Schemes

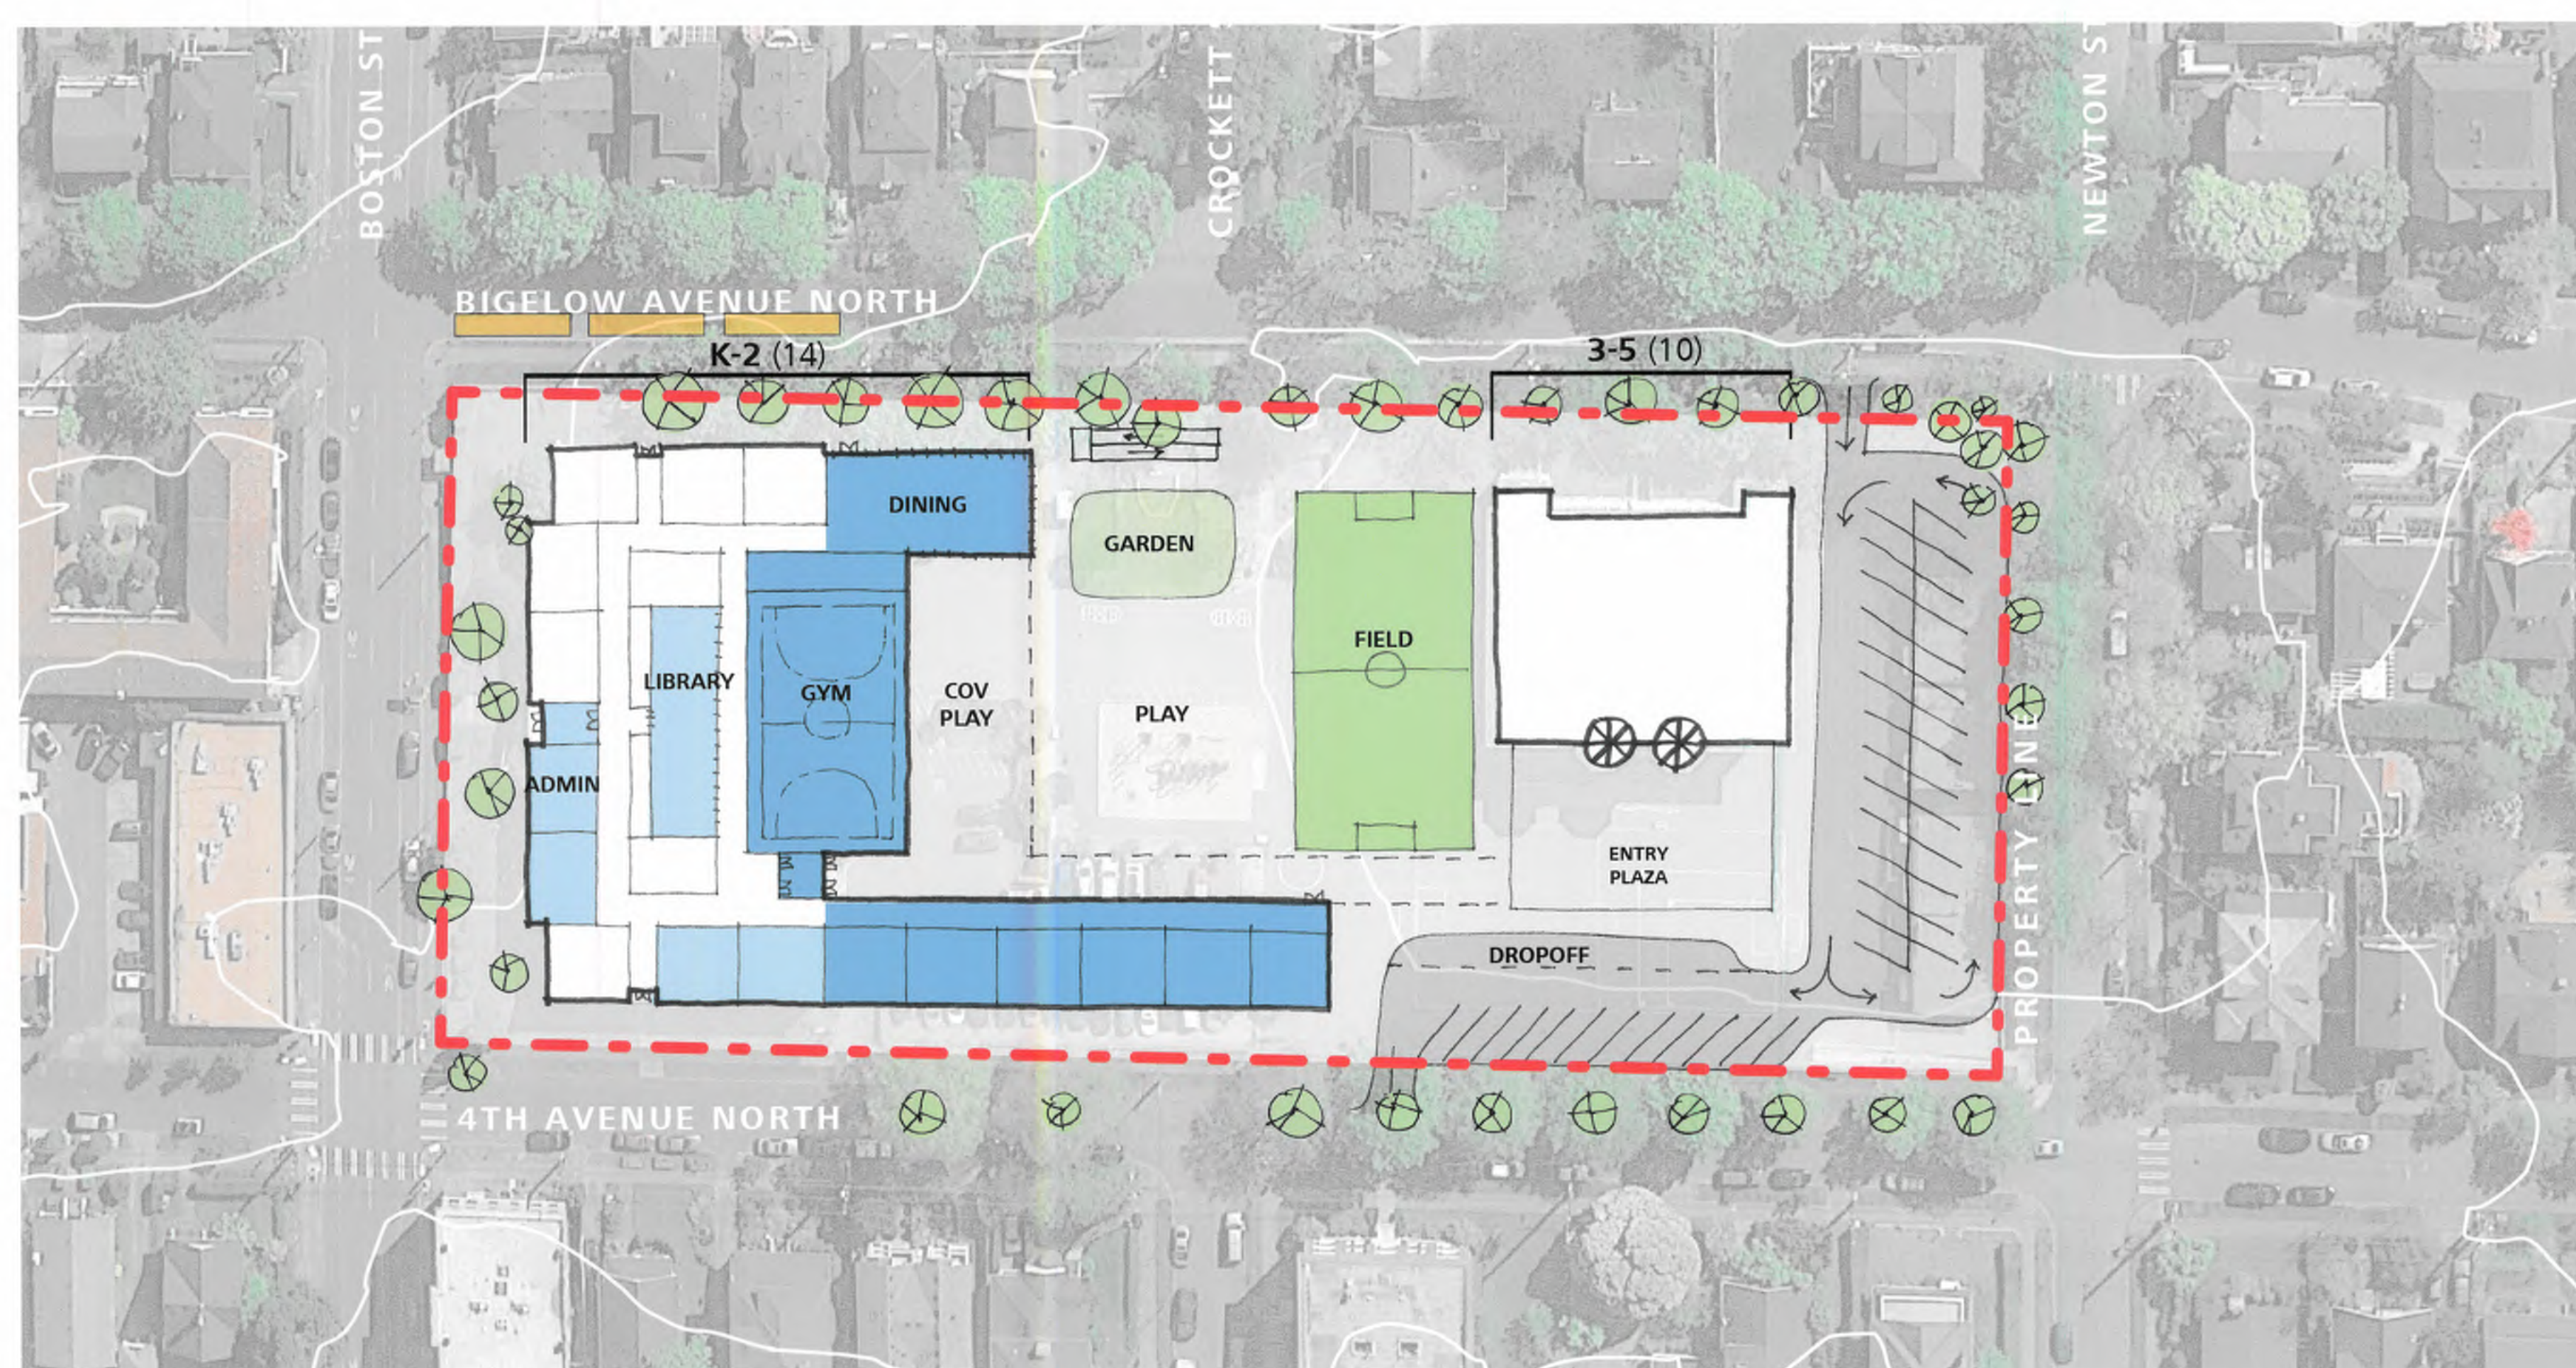
- 1 + SCALE RELATING BOTH BUDGS
+ STAGE CONCEPT
- 2-5 UNITS ABILITY FOR EFFECTIVE BREAKOUT
- DISTANCE TO ADMIN AN ISSUE
+ ADJ. OF ADMIN TO PARKING/DROPOFF
~~FEELING OF DISCONNECT~~
- SENSE OF OPENNESS FROM EAST DROPOFF, NOT WELCOMING WHERE PARENTS CURRENTLY DROP

- 2 + EASIER TO SECURE (SITE)
+ FIELD (FRONT LAWN TO TREEHOUSE)
- GARDEN ADJ TO FIELD
+ ART/MUSIC
EXCEPT MORE BUDGS

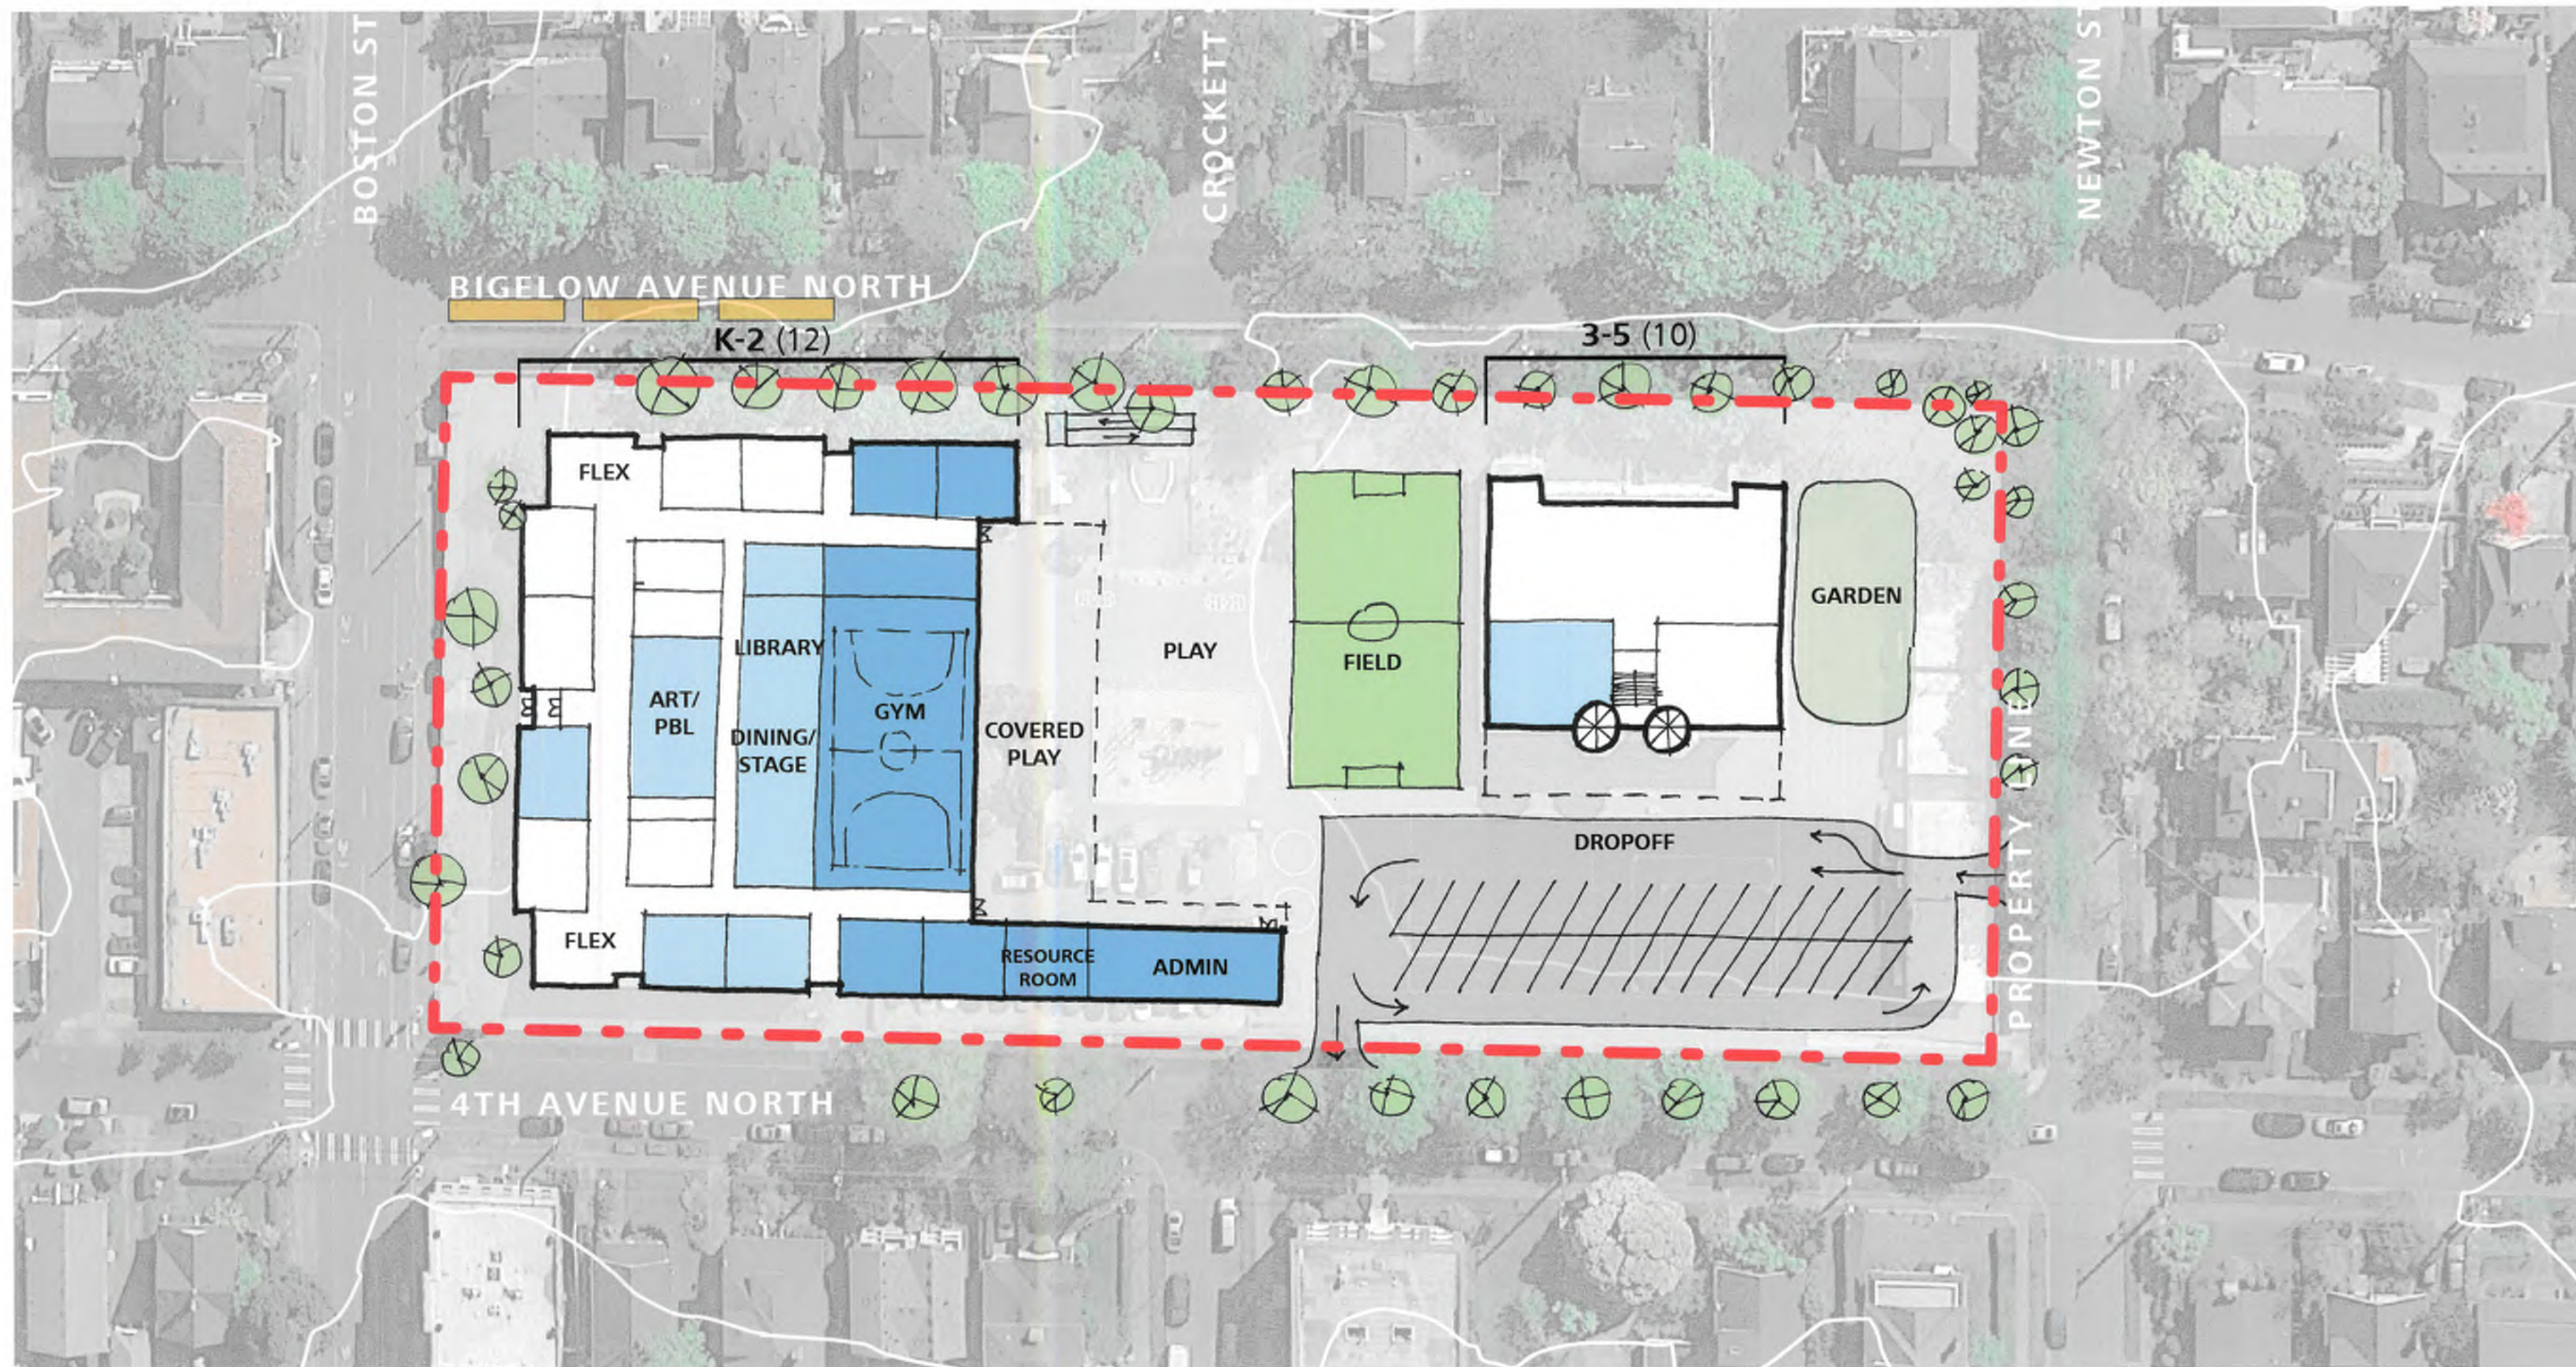
- 3 + SINGLE STORY SCALE
+ FLOW
- LOCATION OF ADMIN
+ LIBRARY AT HEART
+ GYM AT HEART, CENTRAL GATHERING

- 4
- GARDEN LOCATION
 - PROXIMITY OF PARKING TO TREEHOUSE (USE SCHEME 03)
 - + FLEX SPACES

- 5
- + 4/5 MEANS NO SPILT GRADES, AND IT FEELS LIKE GRADUATION

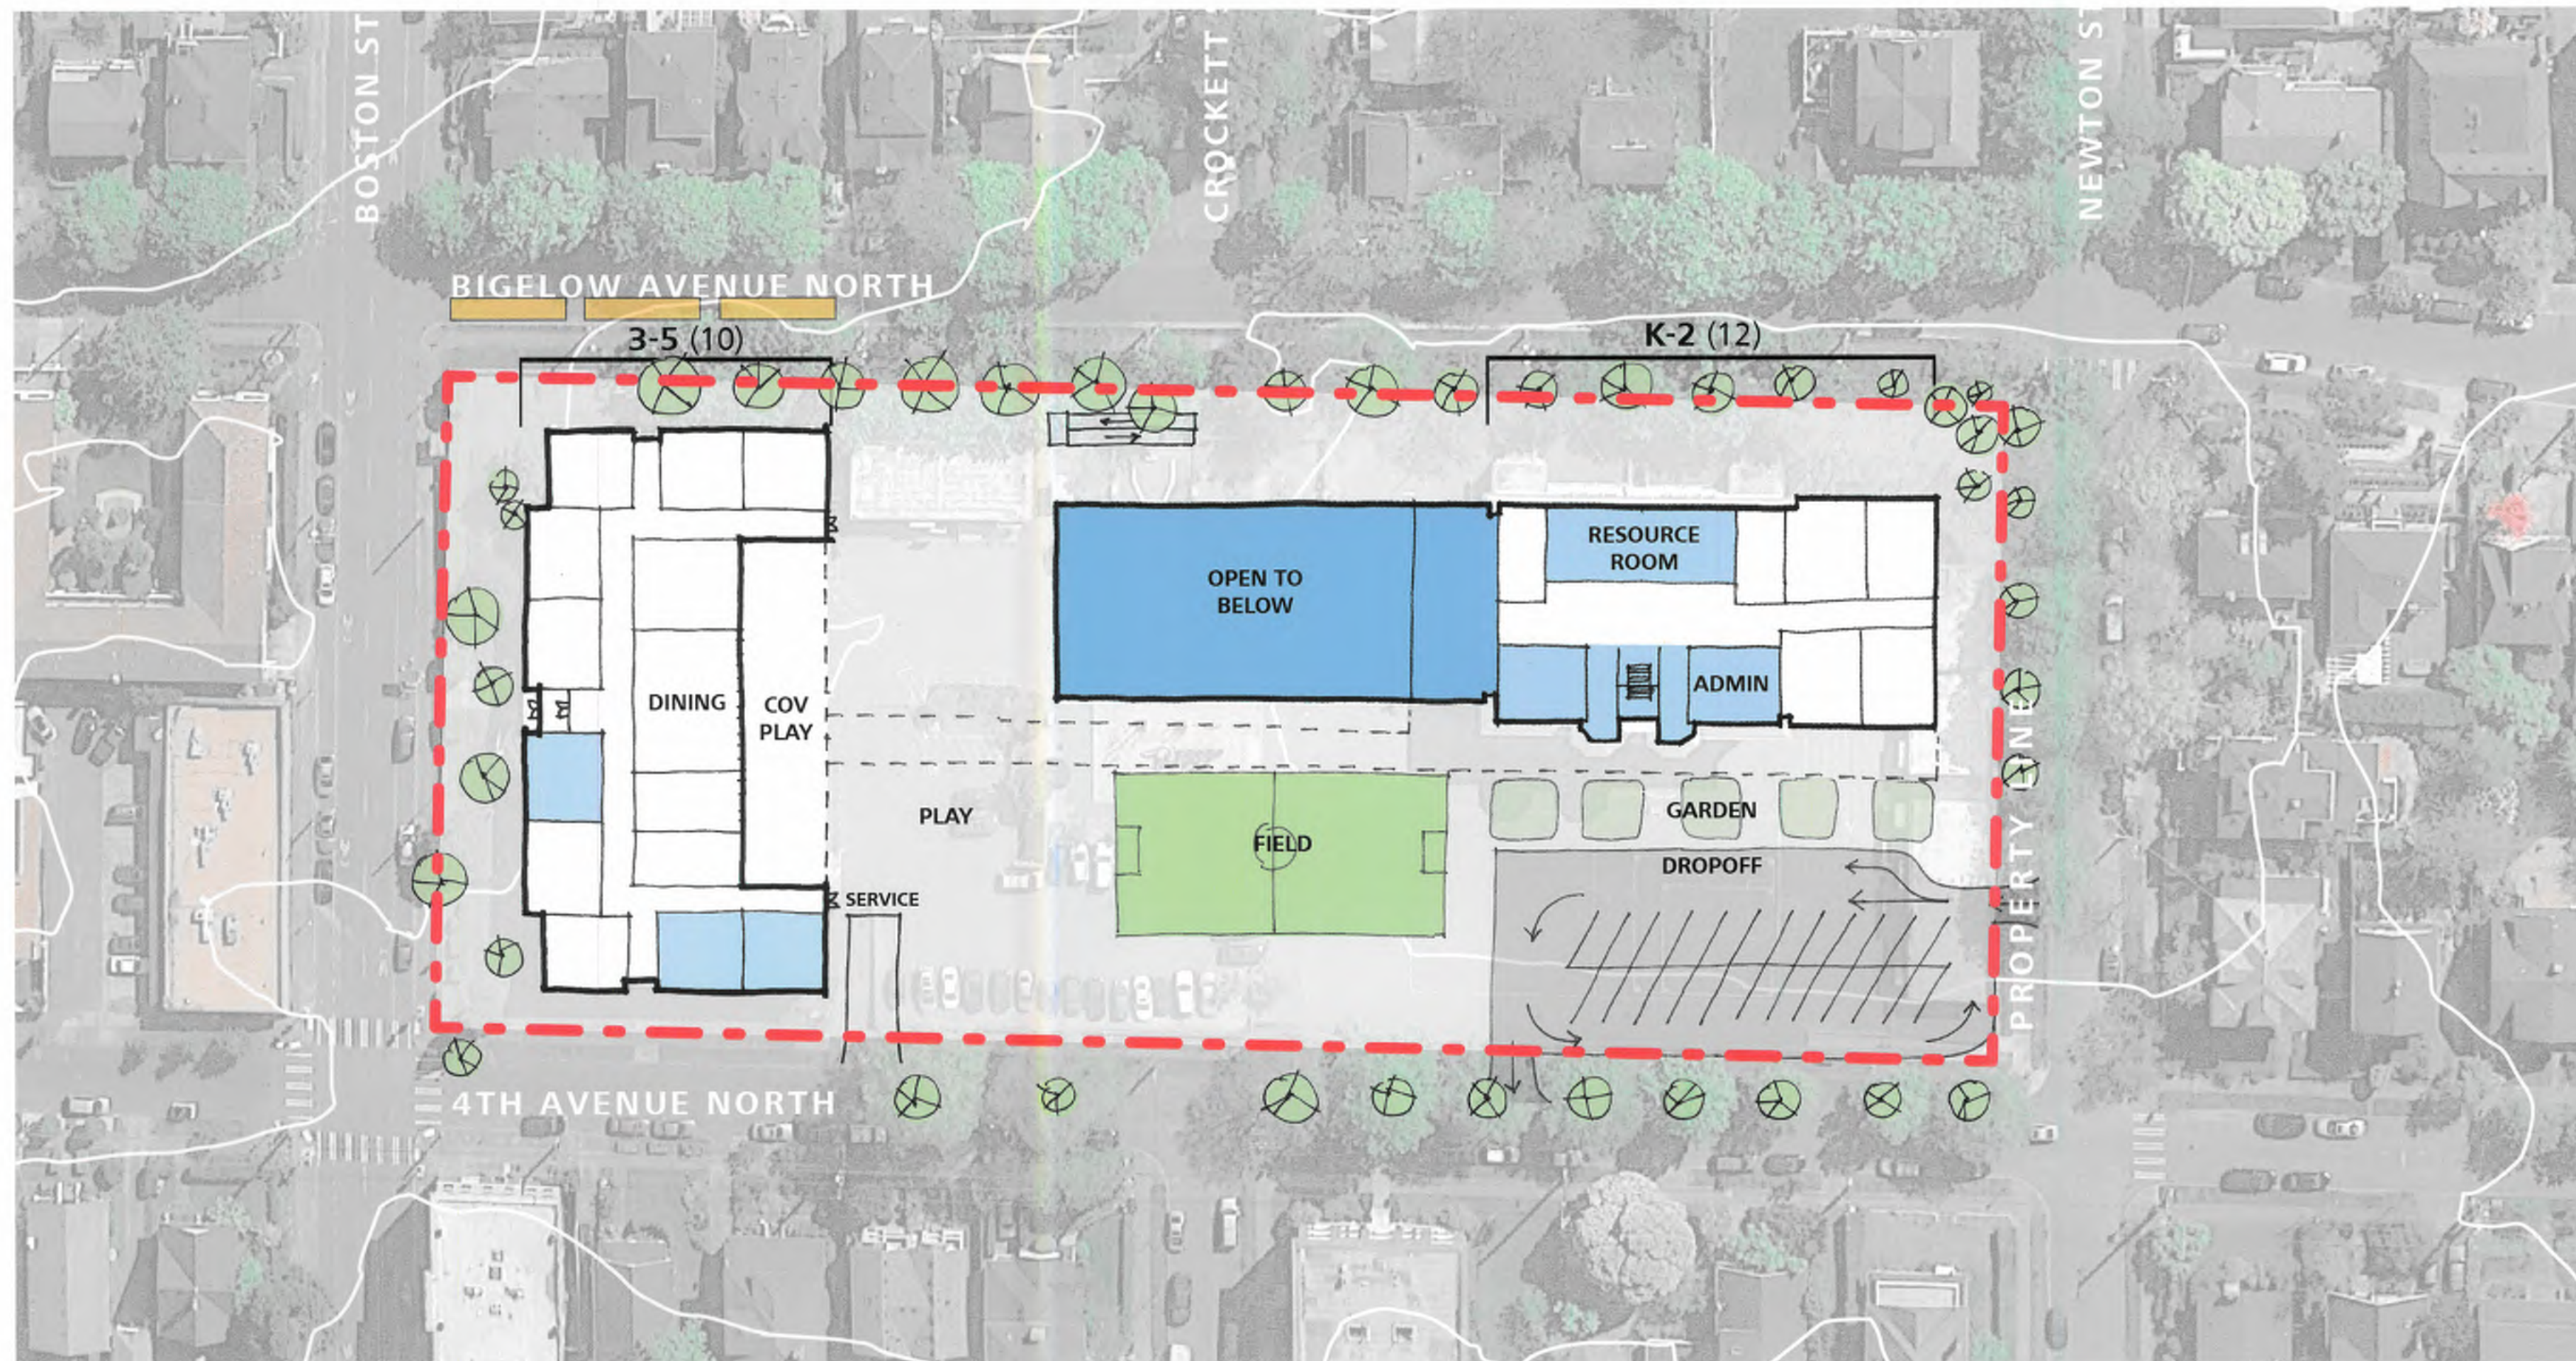
- 6
- ADMIN AWAY FROM YOUNGER KIDS
 - + 4/5
 - + LIKE ADMIN ON 2nd FLR
 - + MAX. OUTDOOR SPACE
 - + LARGE CENTRAL GATHERING AT HEART
 - *- YOUNGER DISTANCE FROM GYM

- 7
- UPPER GRADES IN SMALLER ROOMS
 - PARKING
 - HARD TO ADD
